ADDENDUM NO. 2

Replumb Heating Loop
Potosi Correctional Center
Mineral Point, Missouri
Project No.: C2416-01

POTOSI CORRECTIONAL
CENTER - REPLUMB HEATING
LOOP, INFRASTRUCTURE

M115

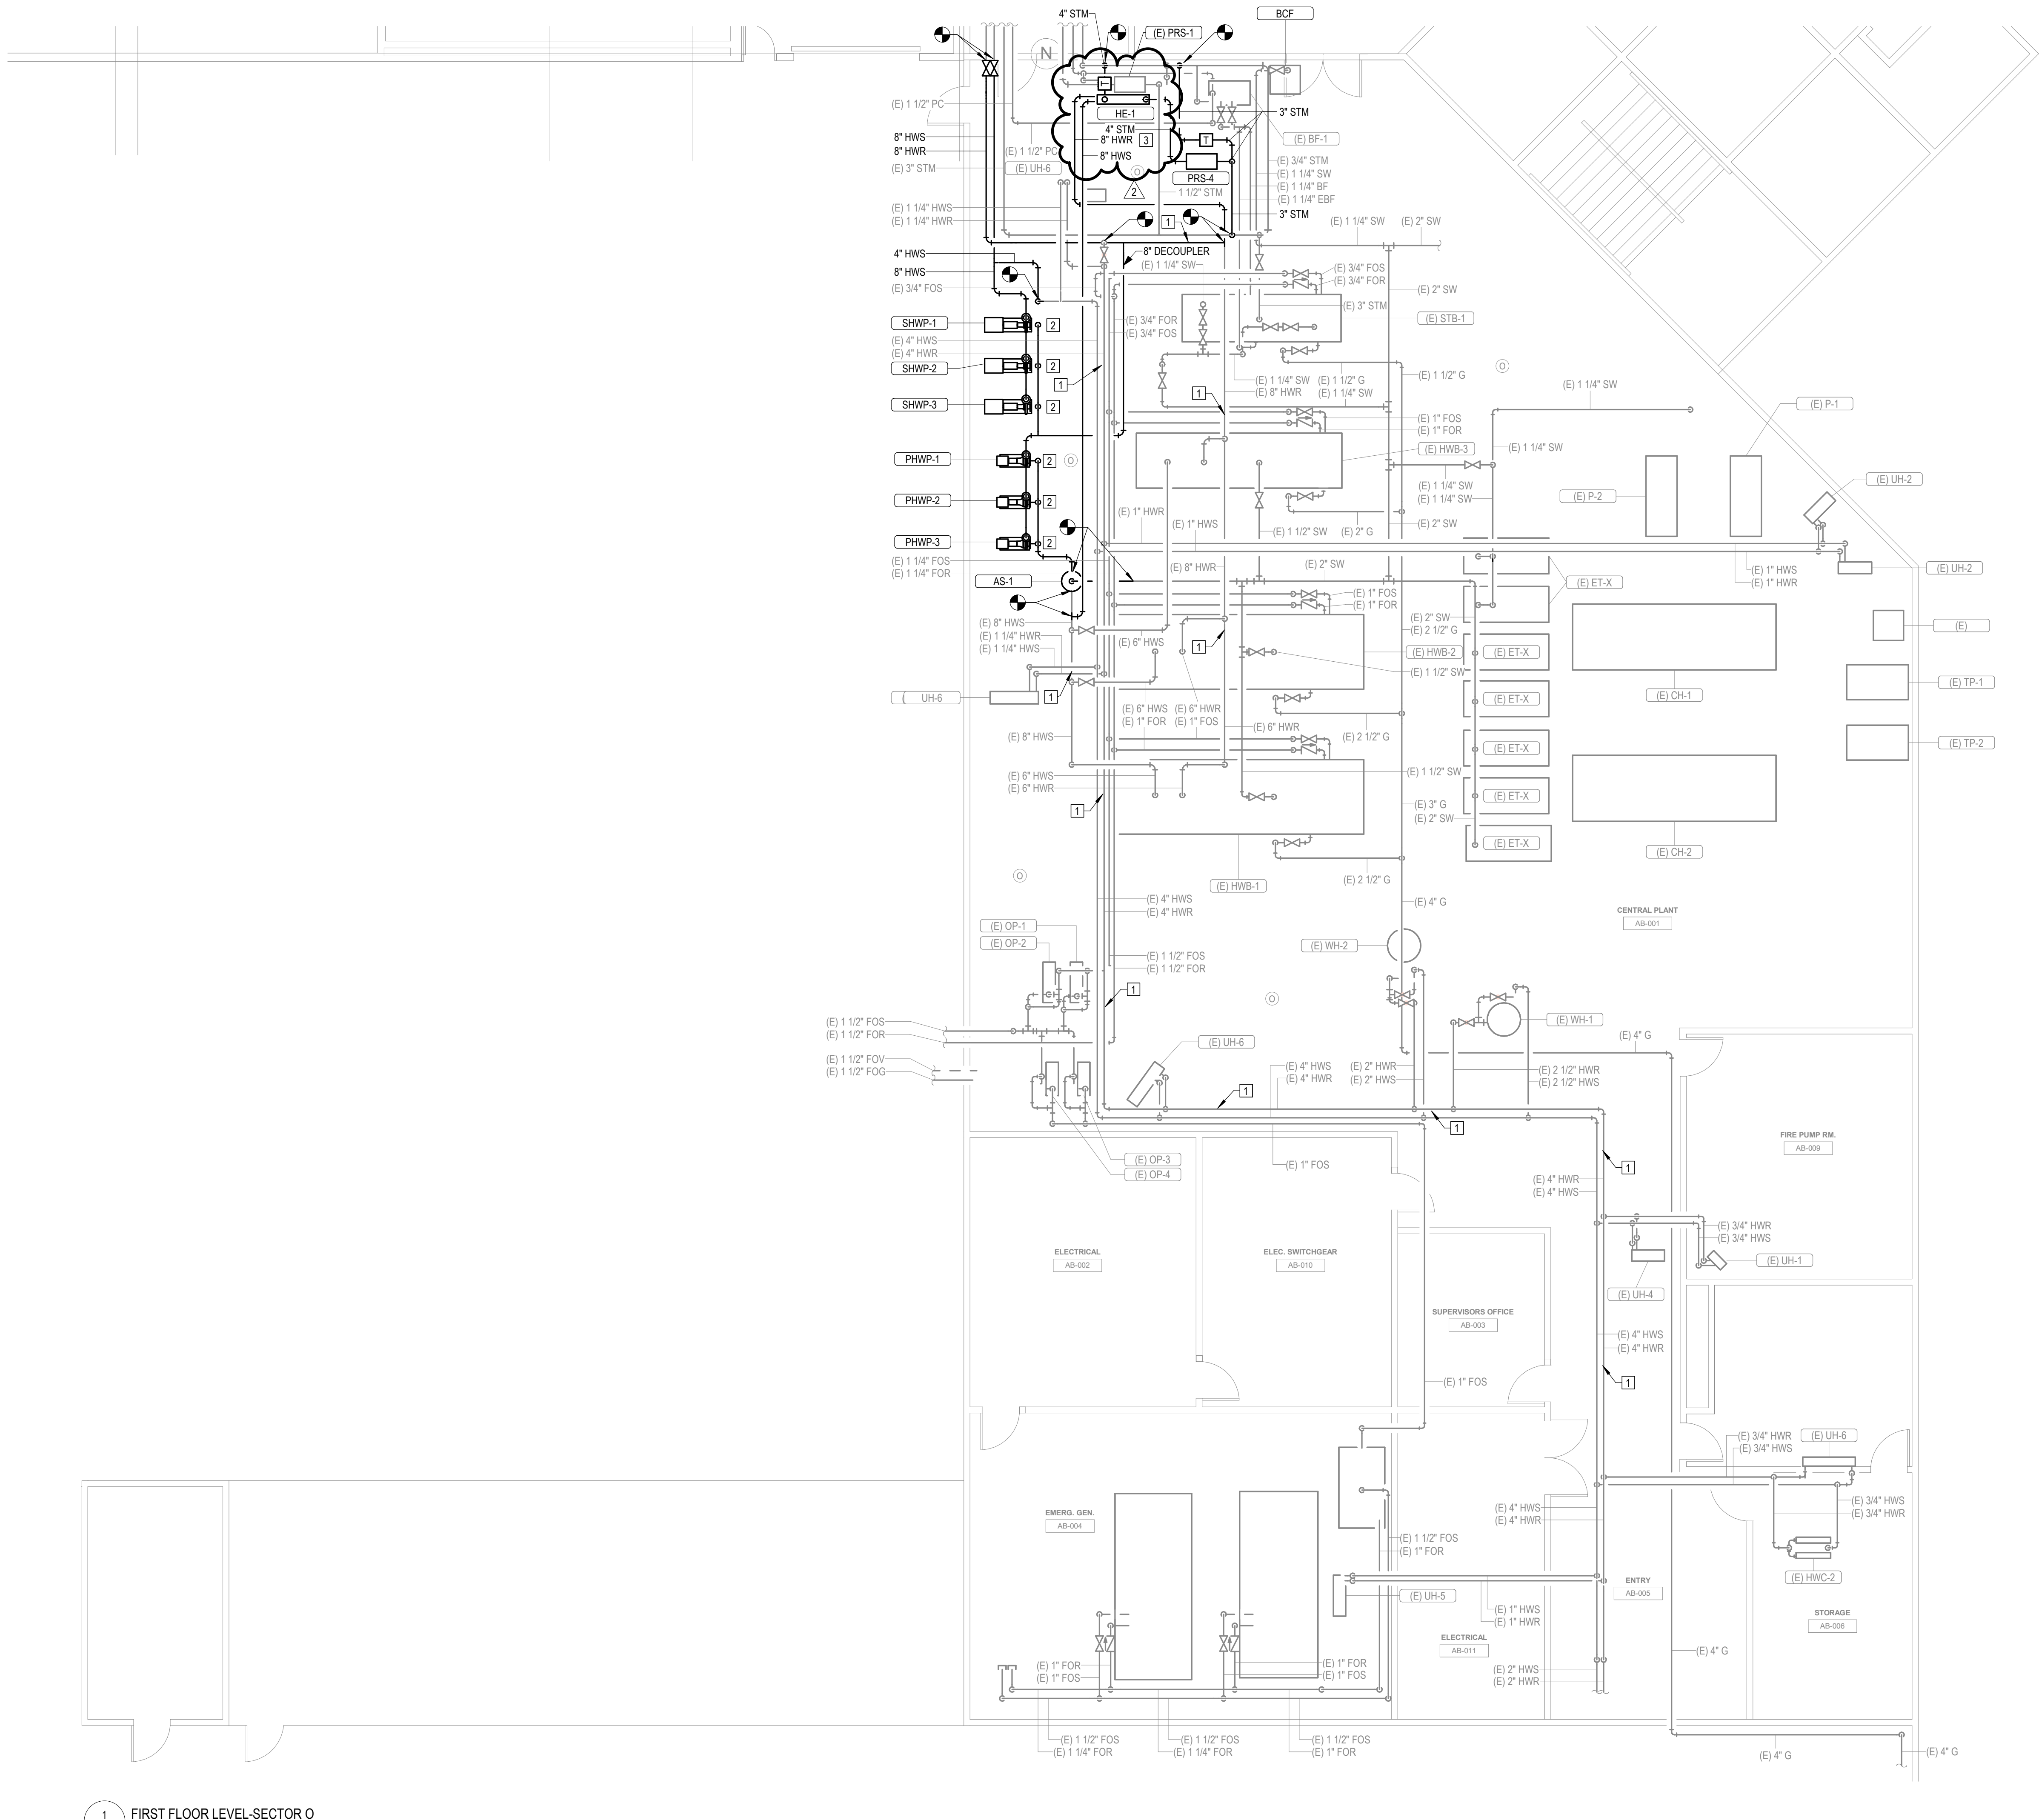
1. Drawing M115 First Floor Level Sector 0

ADD: Keyed Note 3

PROVIDE A TEMPORARY DOMESTIC HOT WATER PUMPING SYSTEM COMPLETE WITH PUMP(S), VFD (OR THROTTLING CONTROL), SUCTION STRAINER, ISOLATION VALVES, CHECK VALVE, FLEXIBLE CONNECTORS/HOSES, PRESSURE GAUGE AT SUCTION AND DISCHARGE, BALANCING/THROTTLING VALVE, AND REQUIRED ELECTRICAL POWER/CORDS. TEMPORARY SYSTEM SHALL BE INSTALLED TO MAINTAIN DHW SERVICE DURING WORK AND SHALL DELIVER 65 GPM AT 50 FT TDH MINIMUM AT THE POINT OF CONNECTION. PROVIDE ALL TEMPORARY PIPING/HOSES, SUPPORTS, SPILL CONTAINMENT AS REQUIRED, AND RESTORE SYSTEM TO ORIGINAL CONDITION UPON COMPLETION. COORDINATE TEMPORARY TIE-IN LOCATIONS AND SHUTDOWNS WITH OWNER.
